In this paper the authors present a very nice laboratory-based experimental study to assess the utility of novel electrical methods for monitoring and quantifying root water uptake and plant stress under partial root zone drying and irrigation schemes in an effort to study plant physiology. They use both electrical resistivity tomography and electrical current imaging, two geophysical techniques that through a computational inversion provide visual and quantifiable evidence for the distribution of changes in electrical resistivity as a proxy for water content and current source density as a proxy for active root pathways, respectively. This experiment was conducted using a single vine grown in a small rhizotron over the course of several months in 2022. In addition to repeated cycles of irrigation and geophysical data collections, the transpiration was monitored using the weight of the rhizotron. Stomatal conductance and leaf area were also measured during one cycle to capture plant stress during a partial root drying event. Aside from a few grammatical errors and some issues with figure quality, this paper is an important addition to the biogeosciences literature, in particular fo

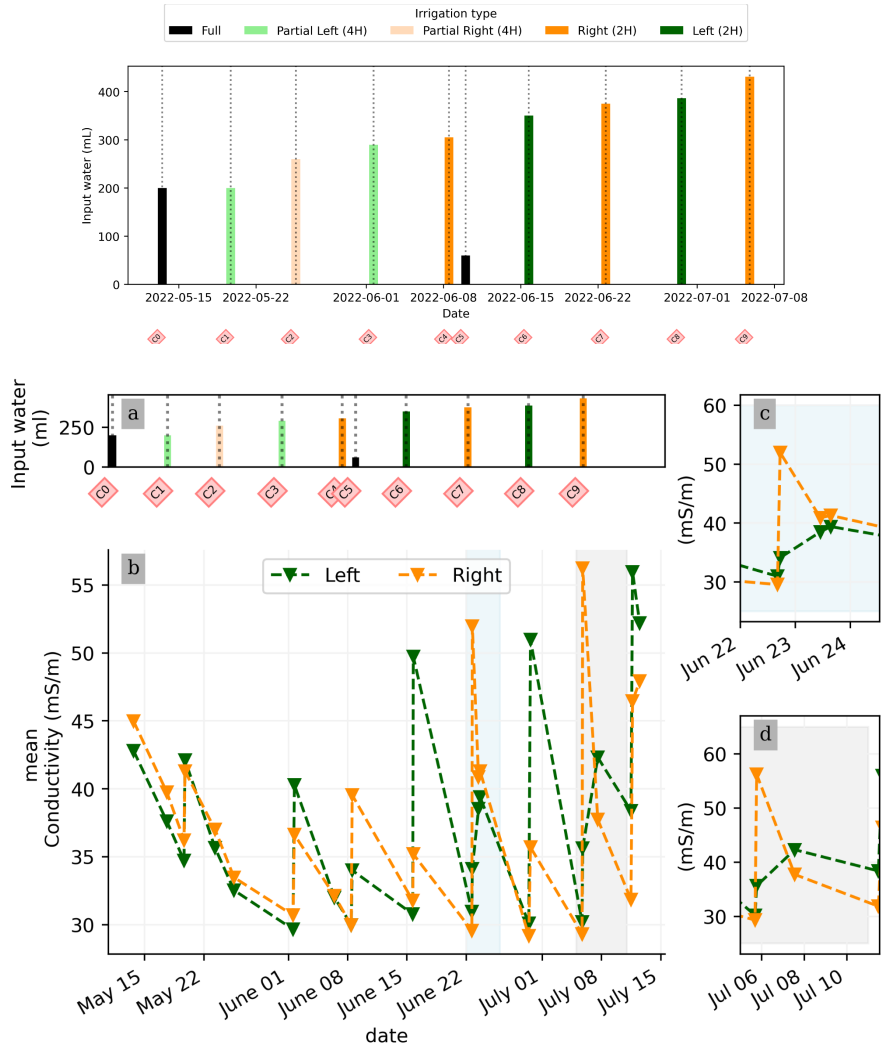
In Figs 4a and 6a, dark green is 'left' and orange is 'right'

In Fig A1 there is a legend at the top indicating the opposite of the caption - that dark orange is partial left and dark green is partial right.

Colors are now consistent between left and right:

- Left = Green
- Right = Orange

Fig A1 was corrected accordingly.

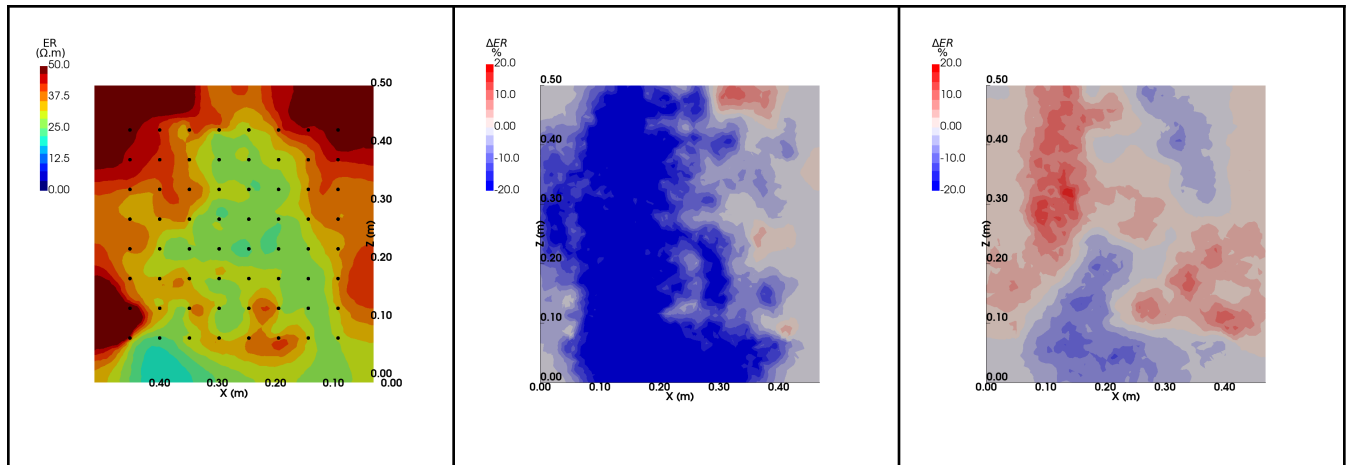
Fig 5 and Fig A9 are the same - labelled time lapse between cycles 5 and 6 - however Figure 5 is captioned 'following partial right irrigation' while Figure A9 is captioned 'partial left-side irrigation'.

Figures A2-A7 label the second image as the next cycle but A8-11 do not and that makes it seem like the cycle number is incorrectly labelled for that entire set of images. Since the time is shown in at least some of the timelapse figures, it would be helpful to have the time of the irrigation in Table 1 (as it is in Table A1) (and to use the same date formatting throughout all figures/tables). I think a combination of the headers would be best i.e. for Fig 5: Background (-1h) = 2022-06-29 16h20, Just After Irrig. (+1h) = 2022-06-29 17h20, Six days after Irrig. = 2022-07-05 17h20, and simple caption this is cycle 6 and add a title to the whole figure that says Cycle 6.

Fig 5 legend rephrased 'following partial left irrigation'. Note that this did not affect the core text description/interpretation.

All the time-lapse ERT figures headers were renamed according to the reviewer's suggestion.

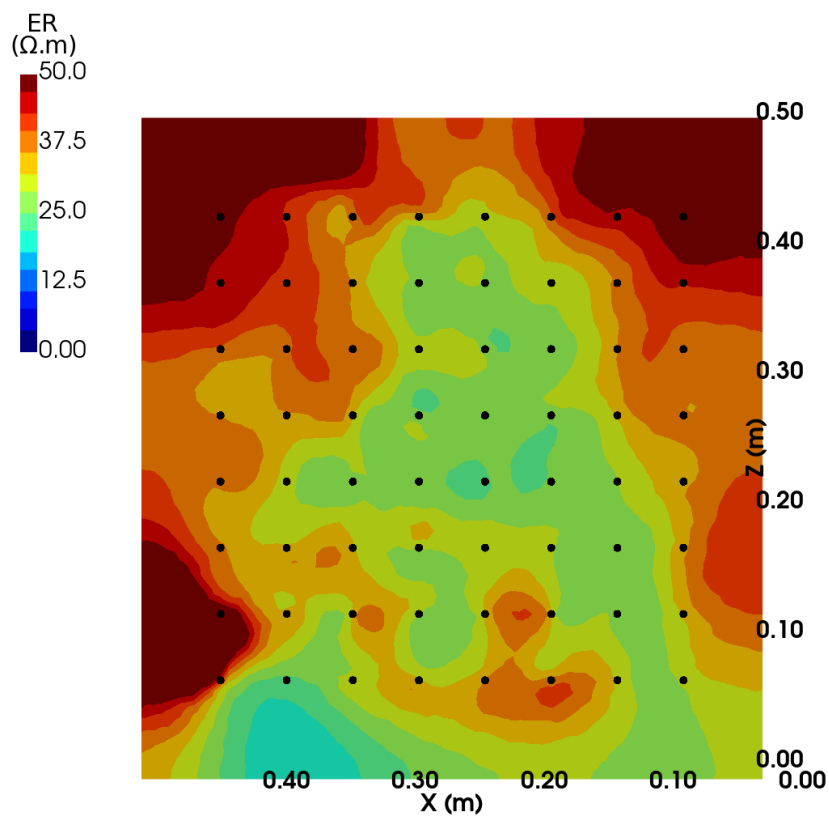
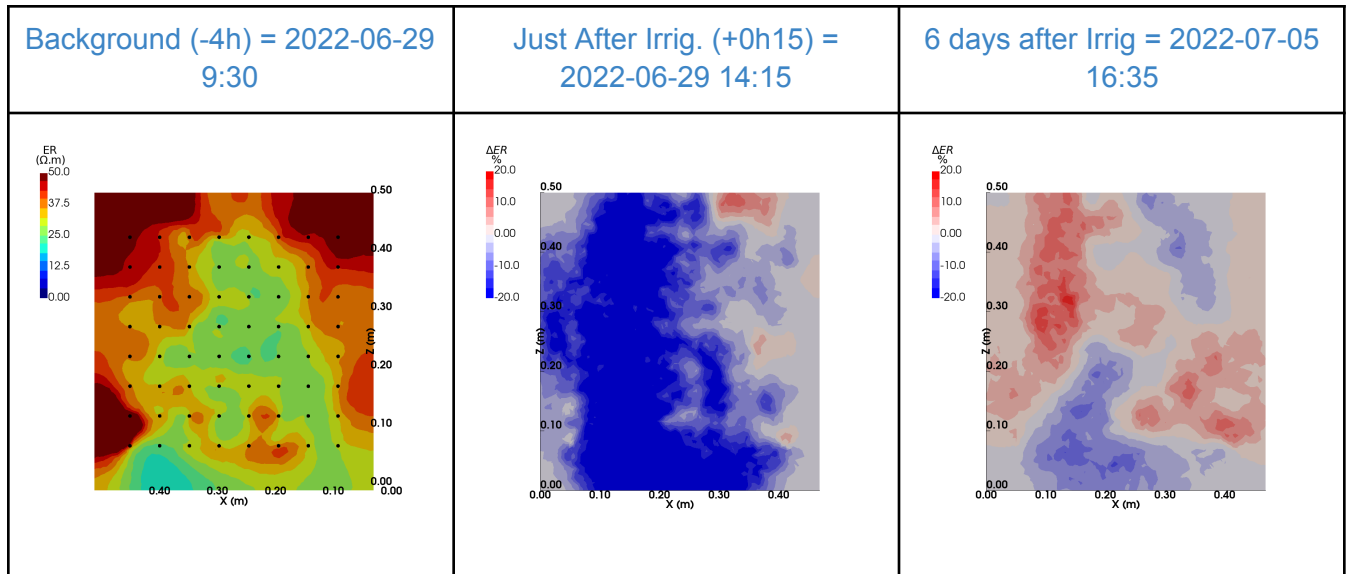
Fig 5 (and A2-A11): the axes labels and legend are too small and low resolution to read clearly

The reviewer is right. We improve the axis label and color bar quality.

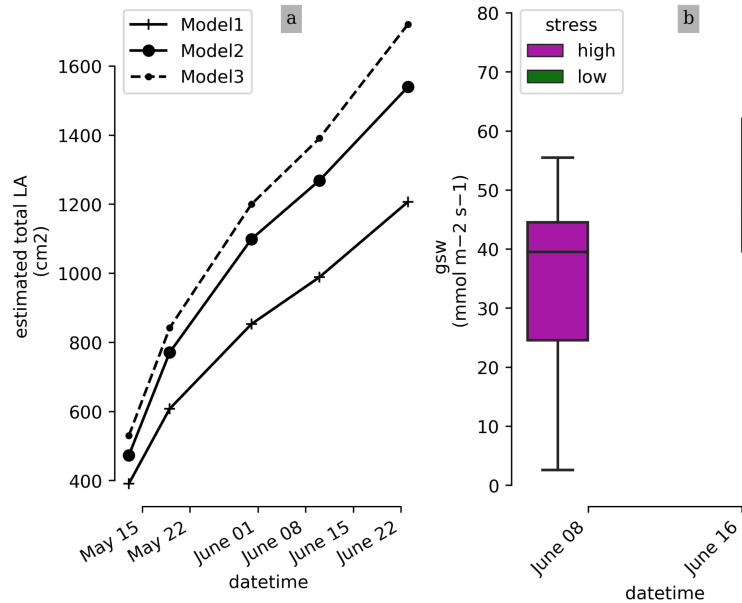
Fig 2b: the time series has a datetime mix up. Labelled August 6 (8/6) instead of June 8 (6/8). It would be helpful to remind the reader in this paragraph (~Ln 351) that the measurements shown come from the 26 leaves which is described back in the methods.

Figure label corrected and sentence rephrased: “*The measurements shown come from the 26 leaves (c.f section 2.5) and indicate that the plant is under high water stress at the end of the irrigation cycle (one week after the last partial irrigation, on June 8,2022), and under lower water stress one day after irrigation (on June 16, 2022).*”

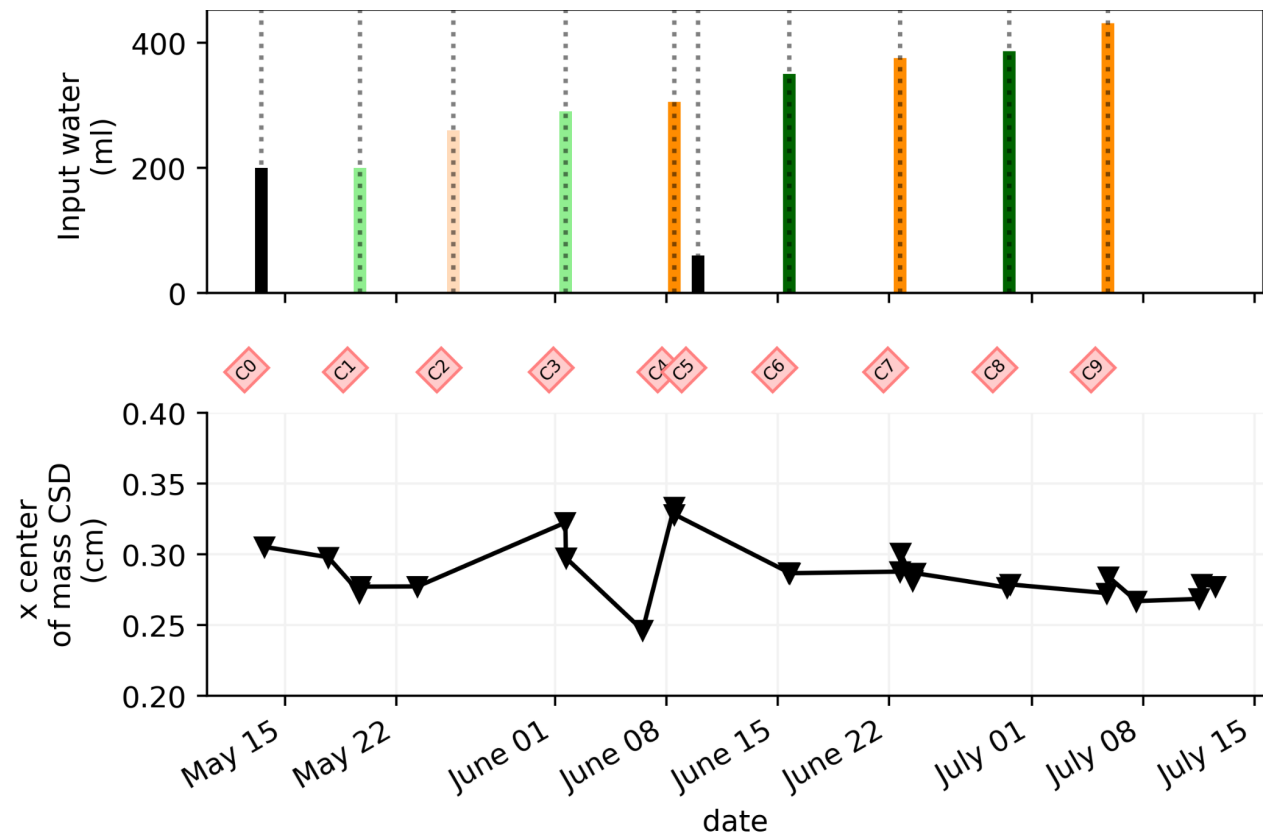
Fig 6: Rescaling the y axis on the center of mass to be narrower would help accentuate any slight variations. This graph should also have a unit (cm?). The caption mentions cycles 5 and 6 were used in Fig 7 but based on the dates it is actually cycles 6-7 (see my point in Major comment 1.3.3 above).

Ok figure improved (scale + unit) and legend corrected
